Subject: Amended MHI's Response to US-APWR DCD RAI No. 464-3520 Revision 0 (SRP 05.04.07)

Amended Response to Request for Additional Information
No. 464-3520 Revision 0

RAI NO.: NO. 464-3520 REVISION 0
SRP SECTION: 05.04.07 – RESIDUAL HEAT REMOVAL SYSTEM
APPLICATION SECTION: 5.4.7
DATE OF RAI ISSUE: 10/6/2009

QUESTION NO.: 05.04.07-11

Figure 05.04.07-11A

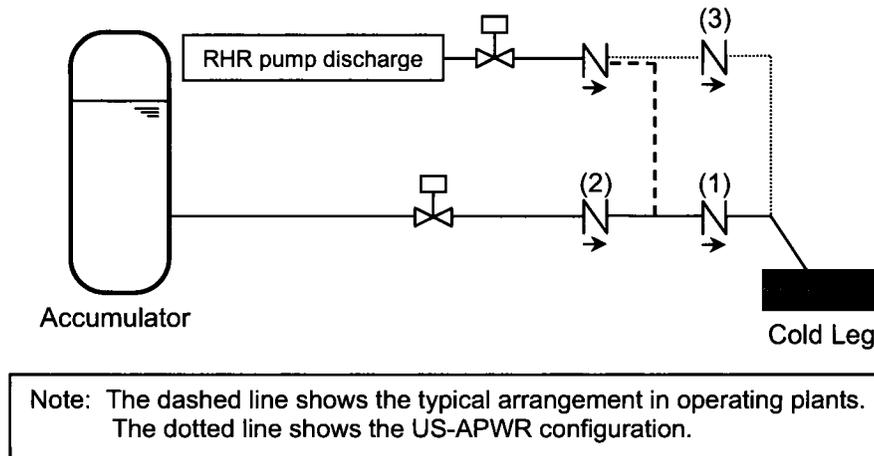
Have potential pathways for gas intrusion in the CS/RHR system been evaluated? If so, identify the pathways. What features are present in the US-APWR design which prevent gas accumulation to ensure CS/RHR system operability? What design features and operating procedures include means for detecting and controlling gas accumulation?

- In current PWR plants, the primary check valve (1) for the RHR and Accumulator system is shared, as shown by the dashed line in Figure 05.04.07-11A. If the water in the accumulator leaks through the secondary check valve (2) during normal power operation, gas accumulation from evolution of dissolved nitrogen in the accumulator fluid can occur in the upstream pipe of the check valve (2).

- In the US-APWR, the nozzles from the RHR pump discharge line to the RCS are separated from the accumulator injection line, as shown by the dotted line in Figure 05.04.07-11A. By this design, there are two check valves between the accumulator system and the RHR system, so potential accumulator leakage into the RHR system is decreased. (Ref: DCD Table 6.3-4, Sheet 10 of 11)

- The US-APWR uses independent primary check valves for the accumulator injection line (1) and RHR return line (3). In addition, there is a normally closed valve between the accumulator system and the RHR system because the RHR system is not used as a low head injection system.
